Access Compliance Report

Public Rights-of-Way

Intersection ID: 28205	Main Street: AUTUMN_APPLAUSE_DR	Cross Street: HICKORY_TREE_LN	Location: NE
ADA ID: 5E93FEBE3AB0	Ramp Type: PerpDiag	Initial Pass/Fail: Fail	Overall Compliance: No
		Severity Score: 47.5

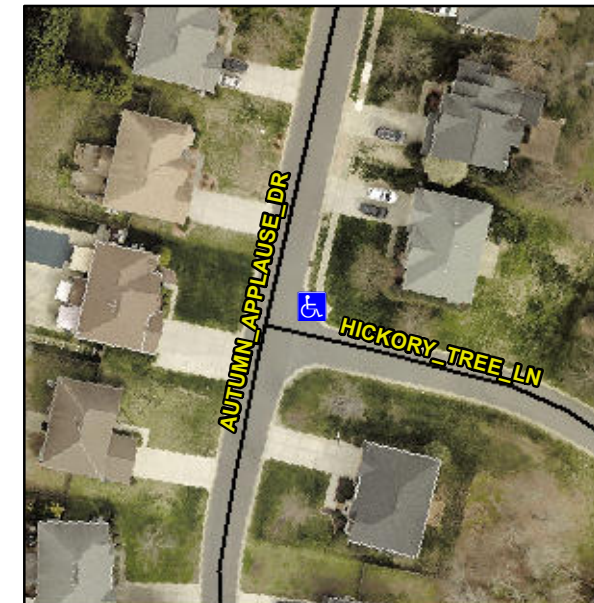
R304.5.1, R304.5.3

Compliance	Description	Data	Compliance	Description	Data
N/A	Ramp Length (in)	97.0	Yes	Ramp Slope (%)	7.5
No	Ramp Width (in)	26.0	No	Ramp XSlope (%)	5.3
N/A	Flare Type LT	N/A	N/A	Flare Type RT	N/A
N/A	Flare Slope LT (%)	N/A	N/A	Flare Slope RT (%)	N/A
N/A	Flare Traversable LT?	N/A	N/A	Flare Traversable RT?	N/A
N/A	Landing Length (in)	N/A	N/A	DWS Provided?	N/A
N/A	Landing Width (in)	N/A	N/A	DWS Contrast?	N/A
N/A	Landing Slope (%)	N/A	N/A	DWS Length (in)	N/A
N/A	Landing X Slope (%)	N/A	N/A	DWS Full Width?	N/A
N/A	Landing Curb? (Y/N)	N/A	N/A	DWS Offset (in)	N/A
N/A	Shared Landing?	N/A			
N/A	Gutter Ponding?	N/A	N/A	Gutter Slope (%)	N/A
N/A	Gutter Lip Ht (in)	N/A	N/A	Gutter X Slope (%)	N/A
N/A	Painted X Walk1?	No	N/A	Painted X Walk2?	No
	X Walk 1 Direction	To SW		X Walk 2 Direction	To SE
N/A	X Walk 1 Width (in)	N/A	N/A	X Walk 2 Width (in)	N/A
	X Walk 1 Slope (%)	2.2		X Walk 2 Slope (%)	0.7
	X Walk 1 X Slope (%)	2.5		X Walk 2 X Slope (%)	3.2

Remove & Replace Curb Ramp With Two New Directional Ramps or Equivalent.
